Application for Amendment

Which permit do you wish to amend? (List permit number and issuing agency.)	LA24011
Legal Land Description(s)	NW 20-11-20 W4 (Qtr-Sec-Twp-Rg-W Mer)

AO note: Approval LA24011 permitted the construction of a rectangular catch basin with the dimensions of 40 m x 12 m x 2 m deep. During a post construction inspection, it was noticed that the catch was constructed in the proposed location, but is triangular with the dimensions of 33 m x 38 m x 50 m x 3 m deep*. This application for amendment seeks to permit the constructed catch basin.

**Re: Geotechnical Review and Evaluation
 NRCB Permitting of Proposed Catch Basin
 NW-20-011-20-W4M, near Iron Springs, Alberta**

SKETCH PLAN
OF
DUGOUT

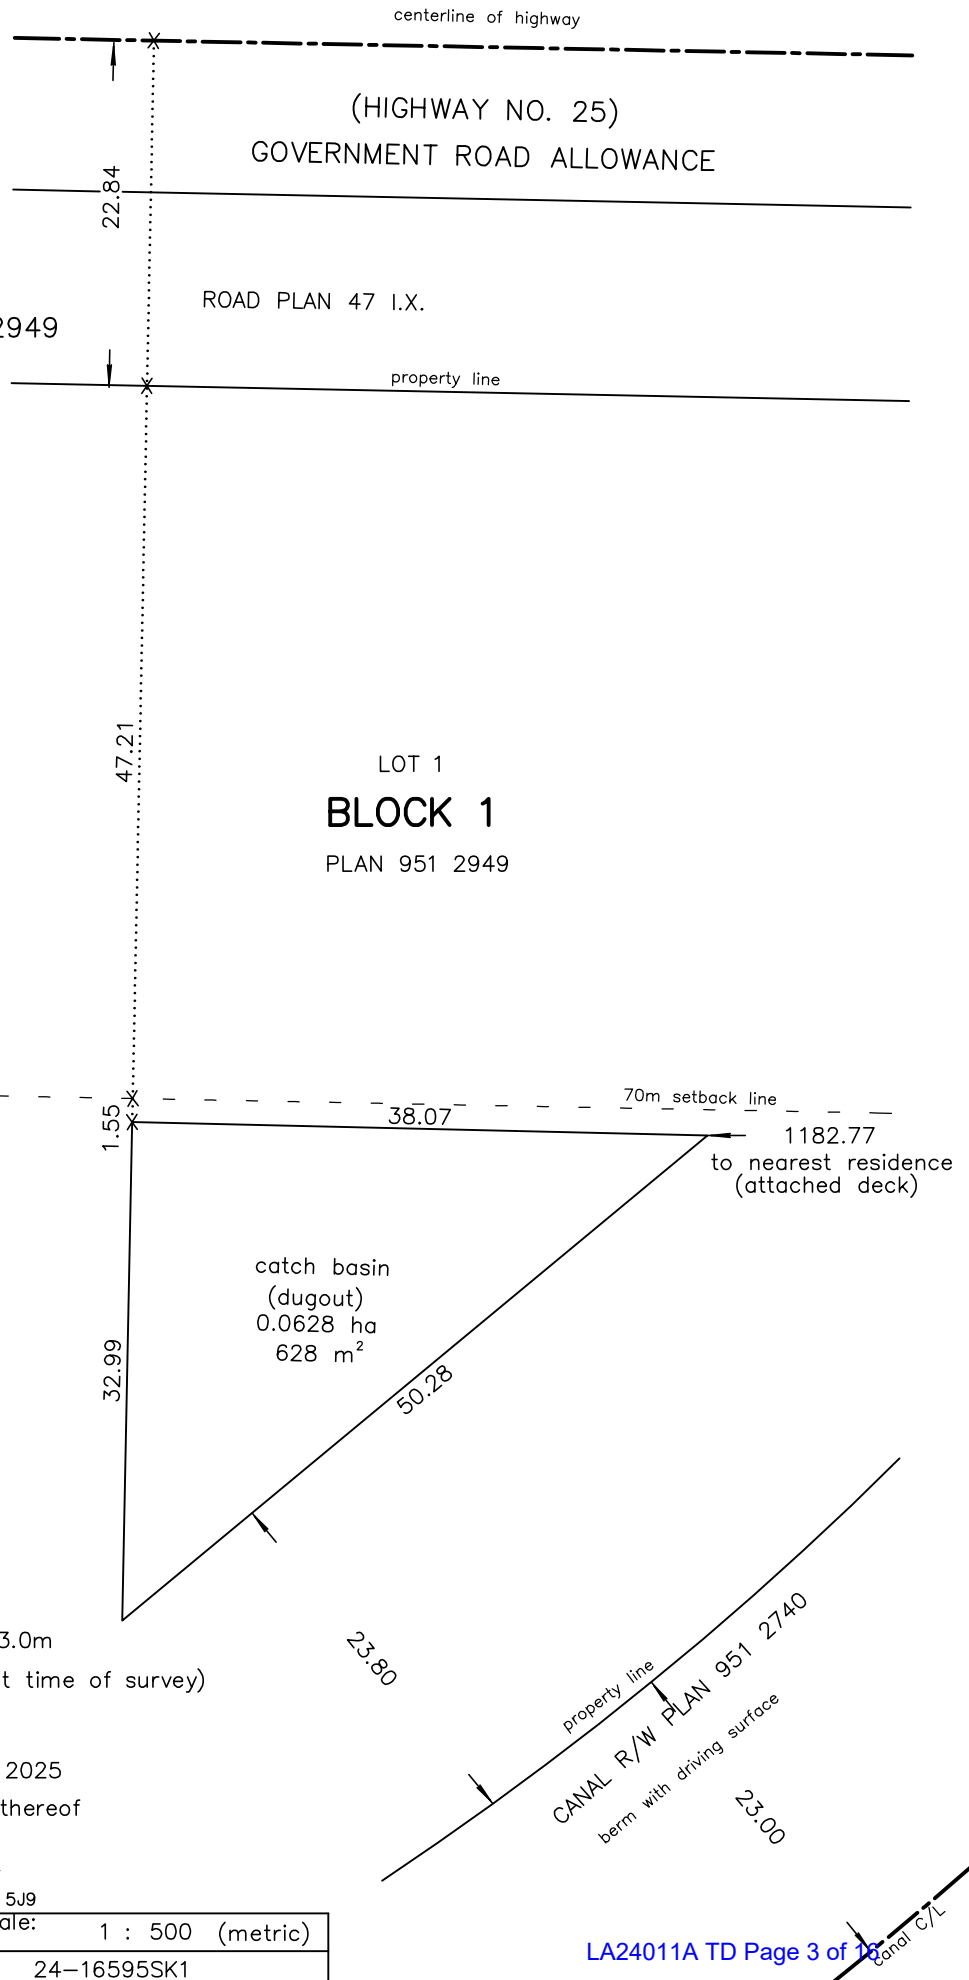
*These dimensions are the surveyed dimensions as provided in the attached report from Brown Okamura & Associates Ltd. These dimensions differ slightly from the dimensions in the diagram above and will be used in the LA24011A decision summary and permit.

Catch Basin Storage Volume Calculator

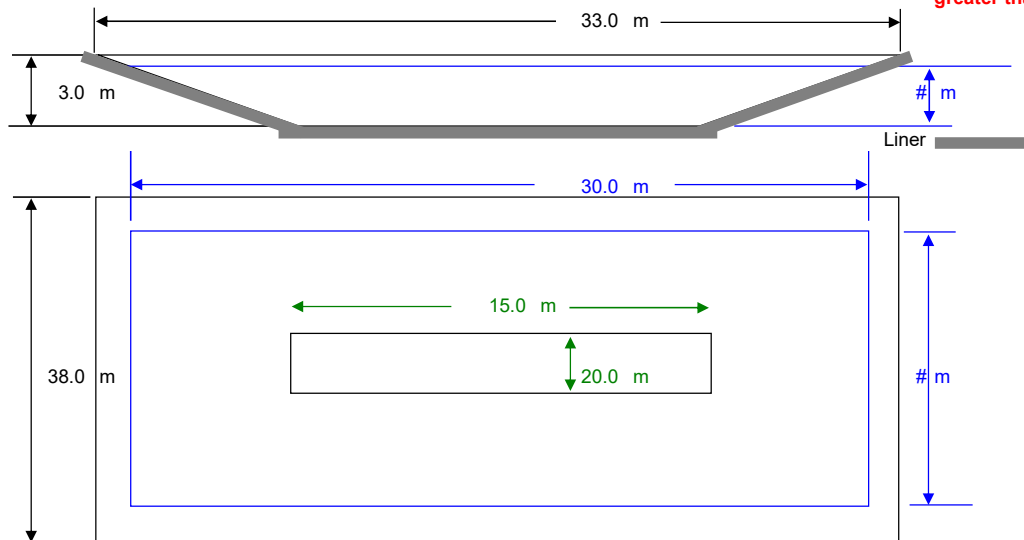
This calculation provides the volume of a rectangular catch basin. The constructed catch basin is a right-triangle, and thus will have a capacity of half this volume (797 m³).
